AMENDMENTS TO ADDRESS RFI 0796 DATED 15th JUNE 2021

ISSUED FOR FURTHER INFORMATION

PROJECT
ADAMSTOWN STATION BLOCK G

DRAWING
GENERAL ARRANGEMENT - LEVEL 05 - FIFTH FLOOR PLAN

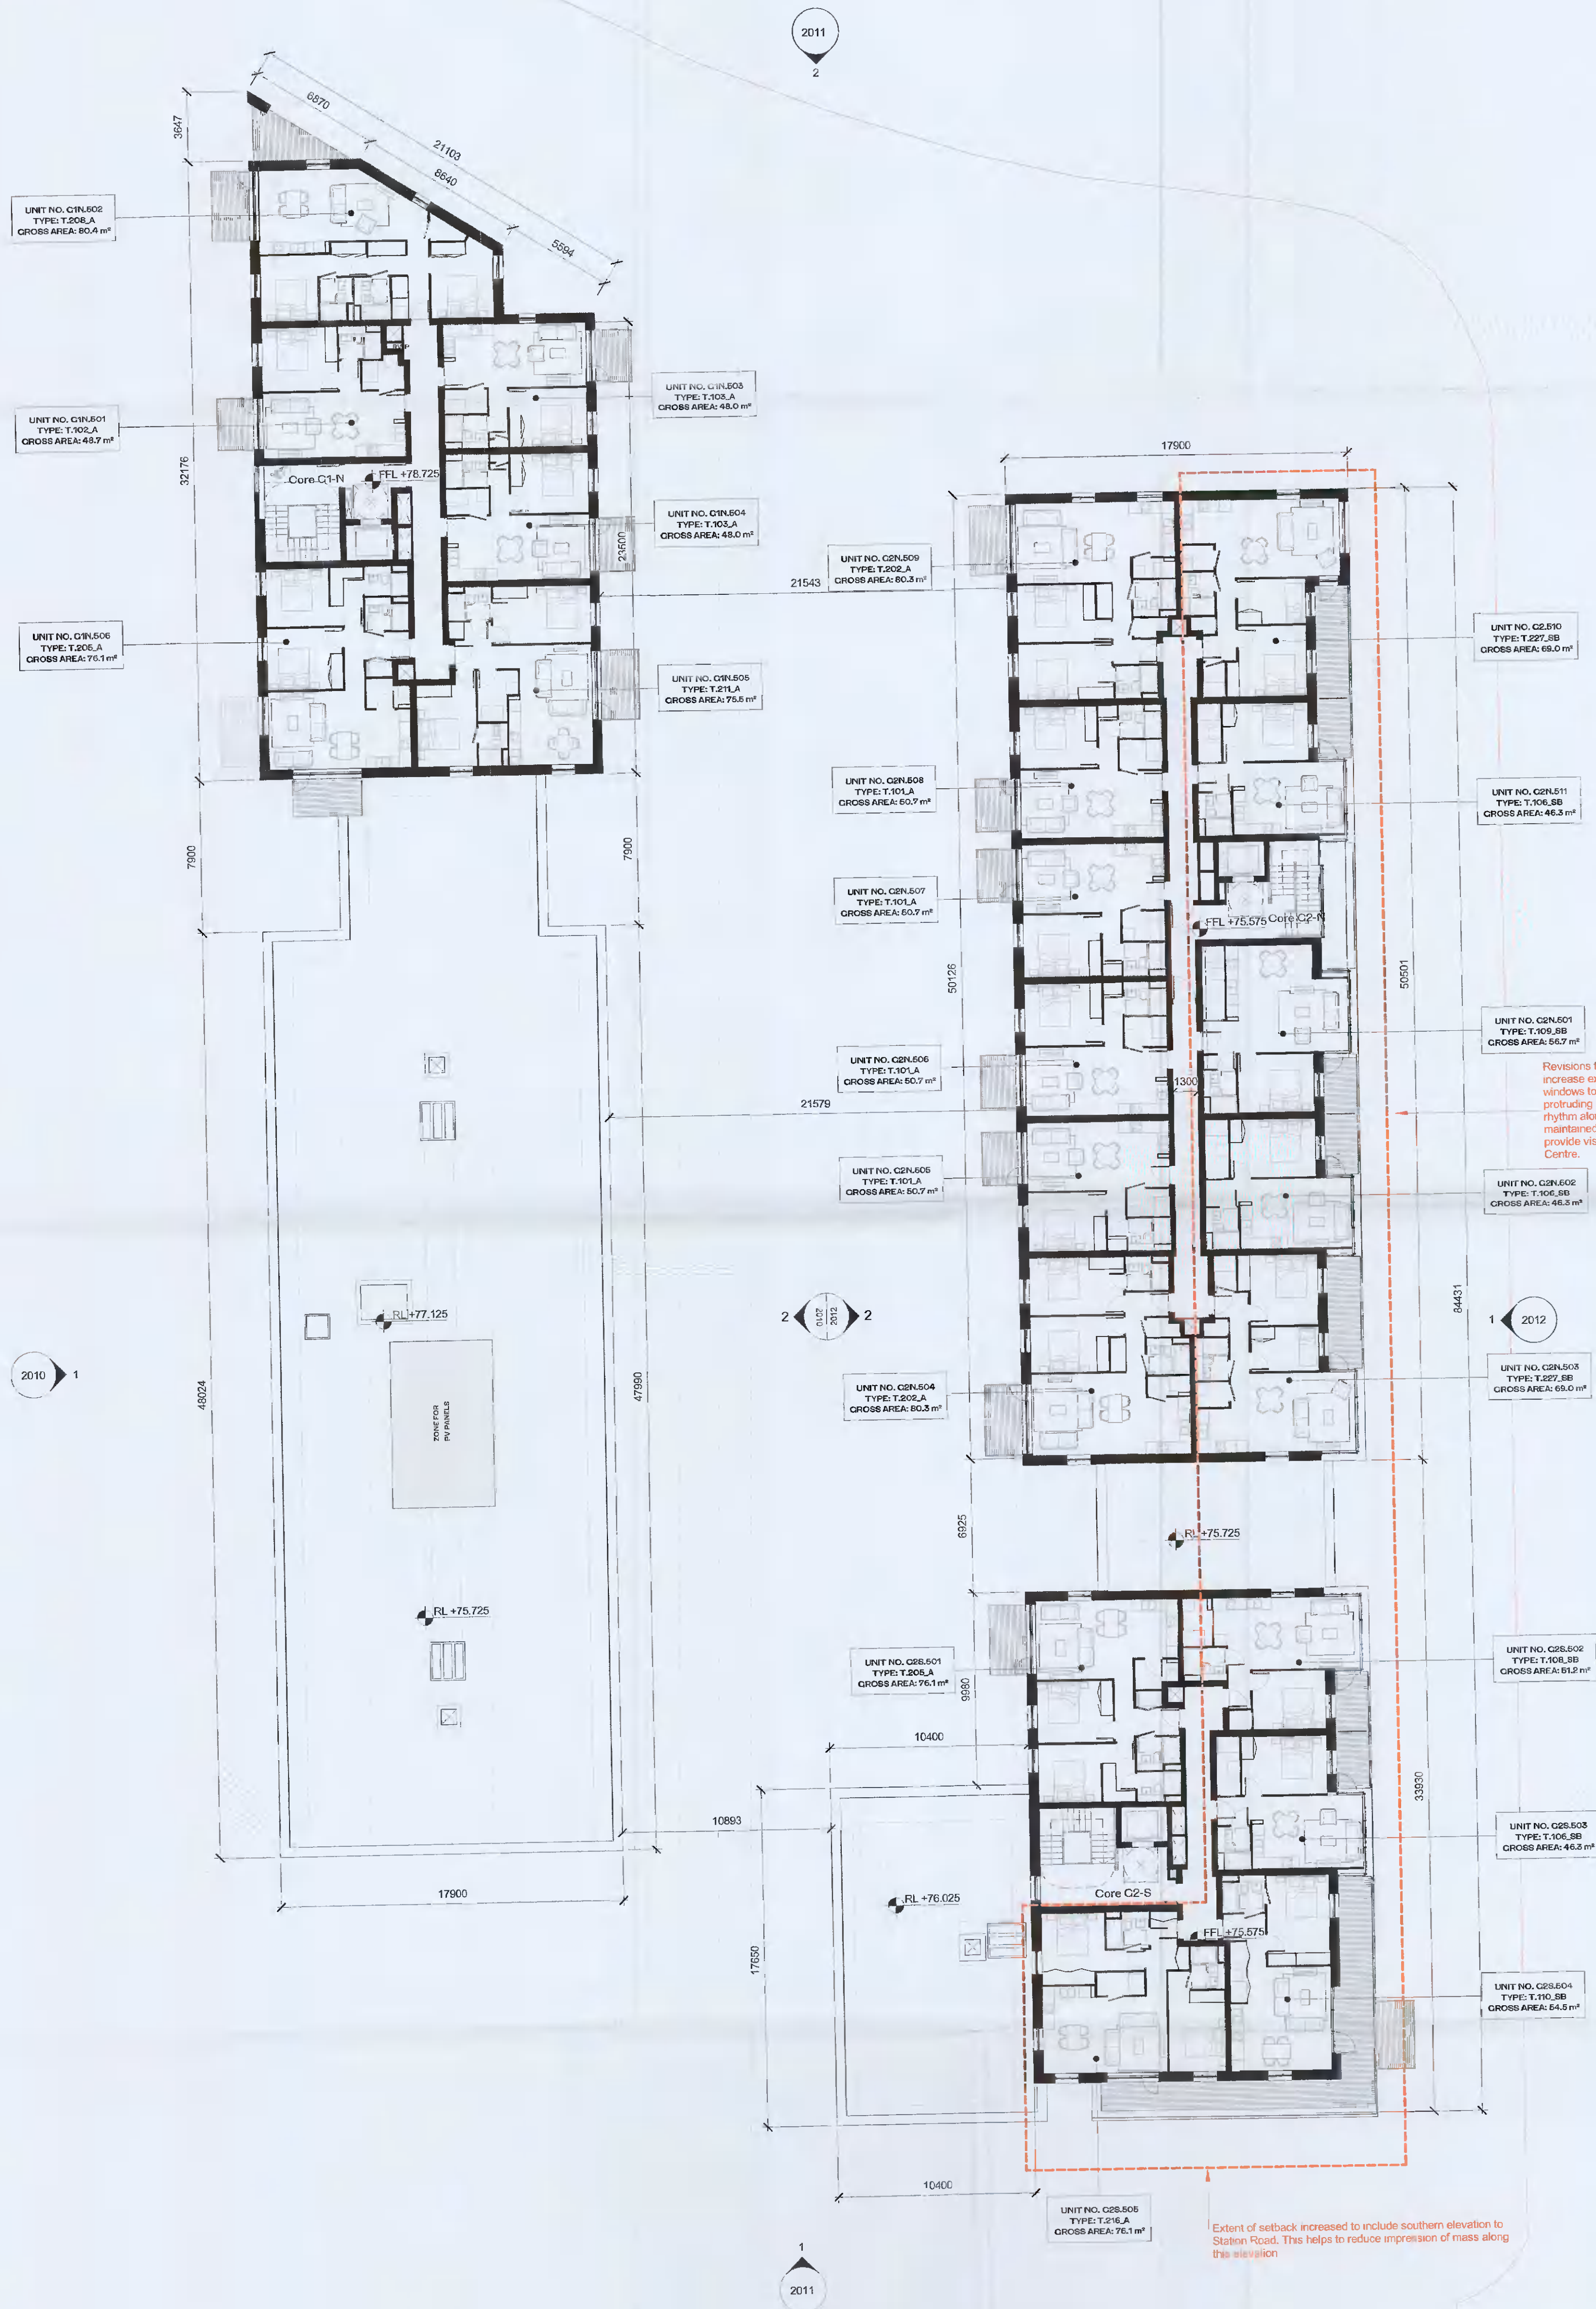
Revisions to setback floor to improve "setback" legibility and increase extent of setback. Living rooms provided with bay windows to create articulation at setback floor and relate to protruding living rooms at ground level. This creates a rhythm along length of Eastern elevation. NE corner maintained as a brick element to "contain" setback and to provide visual prominence at this important gateway to Town Centre.

Extent of setback increased to include southern elevation to Station Road. This helps to reduce impression of mass along this elevation.
